R19AH

Subject: RECALL R19AH – Joint Strength Noncompliance – Insufficient Roof Rivet Quantity

NHTSA Recall Number: 19V-707 School Bus

R19AH – Insufficient Roof Rivet Quantity

Parts/Items Needed:

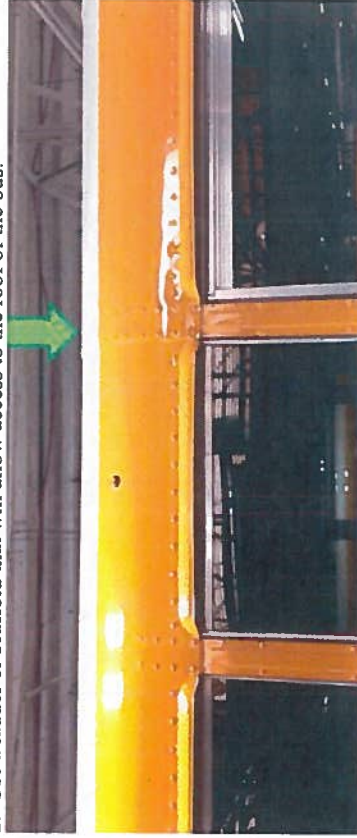
Issue: On certain units, the roof sheet rivet spacing may be incorrect in some segments, resulting in noncompliance with FMVSS 221, School Bus Body Joint Strength.

Corrective Action: Inspect the rivet spacing at each roof sheet joint and install additional rivets, as required by specification.

Item Number	Part Number	Description	Quantity
1	10052610	FASTENER,HUCK,.25 BLIND,MAGNALOK,MGLP-R8-ES	12 (Approximately)
2	NA	*RIVET SPACING TEMPLATE	1

3. Inspect rivet spacing at each roof sheet joint. Roof sheet joints are assembled with two rows of rivets. Joint must have a minimum of six rivets in an eight inch segment. The full length of the roof sheet joint, including the top of the bus, must be inspected and corrected, if needed.

- a. Place the supplied rivet spacing template over the joint and parallel to the edge of the roof sheet, allowing roof rivets to be exposed through the opening in the template, as shown.

- b. Move the template from one side of the roof sheet towards the center of the roof.
 - c. If a segment in the roof joint contains less than six rivets, additional rivets are required. Mark each area that requires additional rivets.

- d. If one rivet is required; add a rivet equally spaced between the two rivets with the largest space in this section.
 - e. If additional rivets are required; add additional rivets between the largest spaces until a minimum of six (6) rivets have been added in the eight (8) inch segment.

4. Using a short 17/64" drill bit, drill a hole through the roof sheet and bow flange only. **Be sure not to drill through the inside headliner.** Drill any required holes on a common centerline with existing rivets.

5. Install rivet (Item 1) in each drilled hole.
6. With the correct color paint, touch up each blind rivet installed.
7. Repeat procedure on the opposite side of the bus.
